County Development Plan 2022-2028

**Proposed
Material Alterations
to Proposed Variation
No. 1**

**Proposed Material Alterations to
Proposed Variation No. 1
of the Dún Laoghaire-Rathdown
County Development Plan
2022-2028**

May 2026

Non-Material Change No. 1

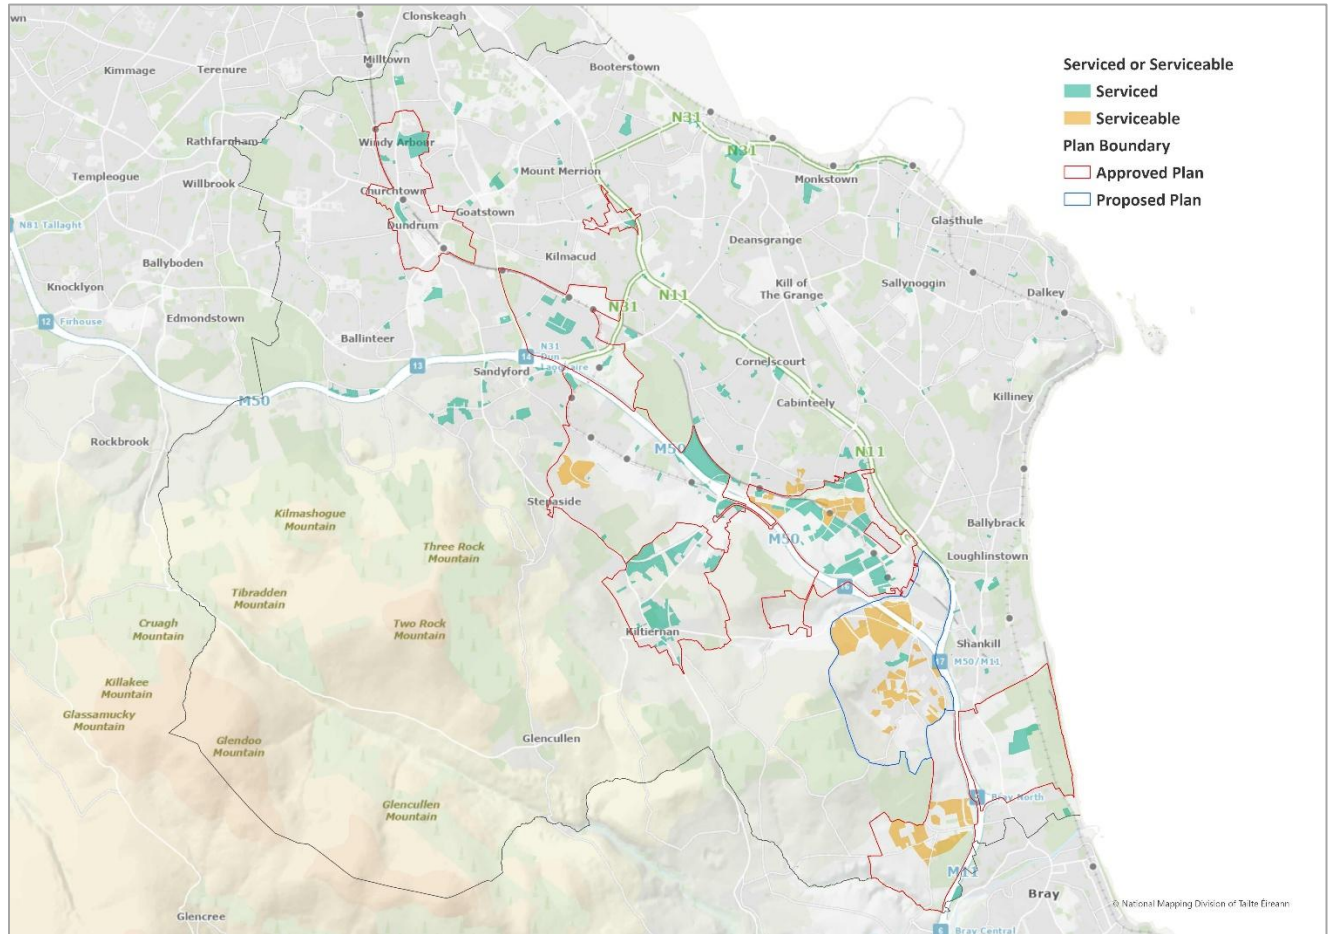
Amend **Proposed Variation Item No. 1** Figure 2.9A: RDCA 2025 – Serviced and Serviceable Lands to include plan boundaries, as follows:
